ADDENDUM
to the
MITIGATED NEGATIVE DECLARATION

BURNEY WATER DISTRICT

WELL NO. 9

February 2022

BURNEY WELL 9 SITE PLAN

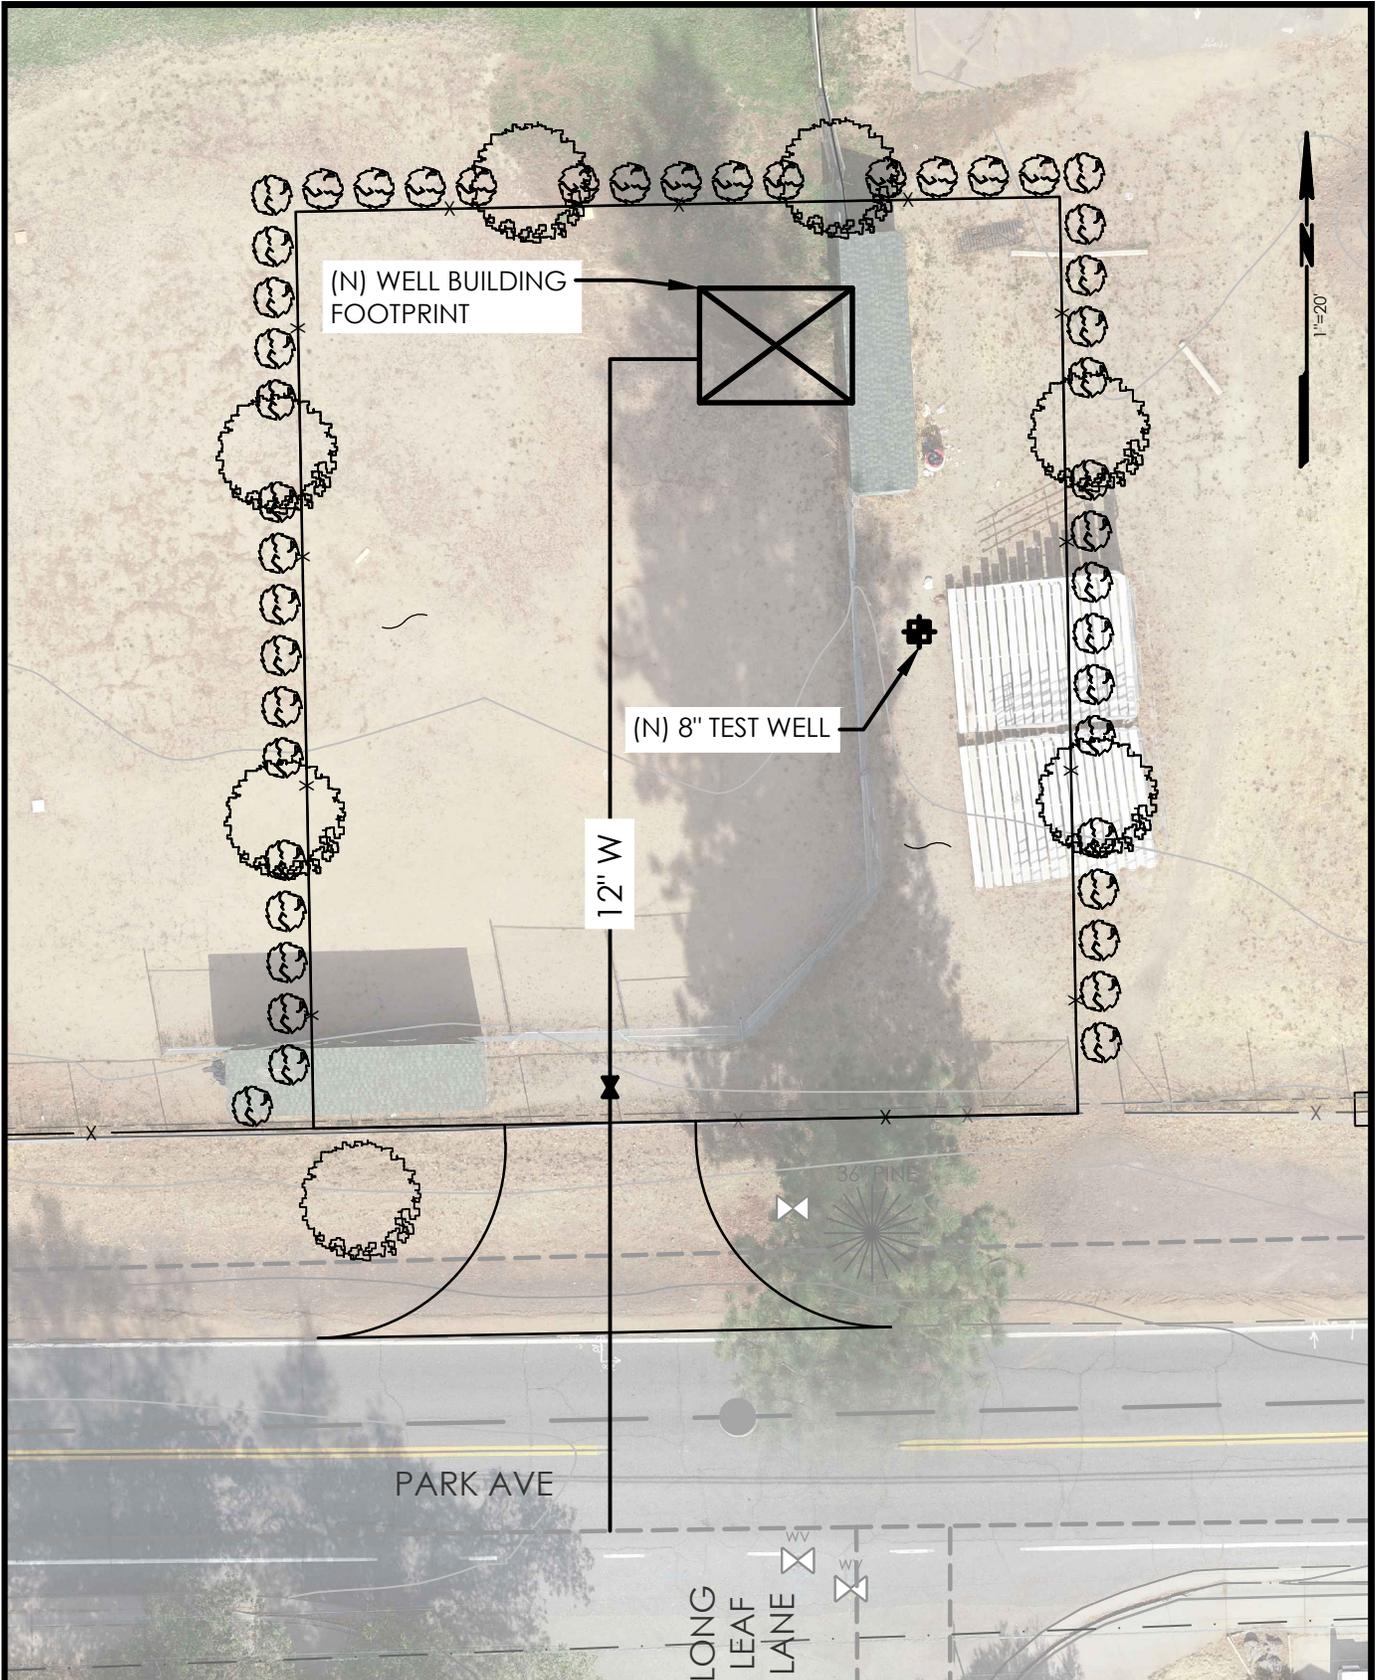
BWD is currently pursuing funding for the proposed project through the State Water Resources Control Board's (SWRCB) Drinking Water State Revolving Fund (DWSRF) program. The current project is substantially the same as the project previously addressed in the 2005 IS/MND, with minor amendments as described below. **Figure 1** is a vicinity map of the modified project area. **Figure 2** is a site plan showing the modified project.

As revised, the proposed wellhouse would be installed ± 200 feet southwest of the original location. This would change the location of the 12-inch waterline that would extend from the well to an existing waterline in Park Avenue and the electric service line that would be installed underground from the wellhouse to an existing power pole south of Park Avenue. As shown in **Figure 2**, a fence would be installed around the well site, and landscaping would be installed around the perimeter of the fence. Access to the wellhouse would be from a new driveway off of Park Avenue. An emergency back-up generator would be installed adjacent to the wellhouse within the fenced area.

As discussed in the Initial Study, the intent of MM A-1 is to minimize visual impacts of the wellhouse from public vantage points. Because planting shrubs and trees around the perimeter of the building in accordance with MM A-1 would not provide screening of the fence, the modified project proposes installation of landscaping around the perimeter of the fence to provide visual screening of both the fence and wellhouse (see **Figure 2**). Therefore, MM A-1 has been revised as follows:

***MM A-1 (revised):** Landscaping, including bushes and 15-gallon trees, shall be planted around the perimeter of the wellhouse fenceline and/or in other areas of the well site as appropriate to minimize visual impacts of the fence and wellhouse.*
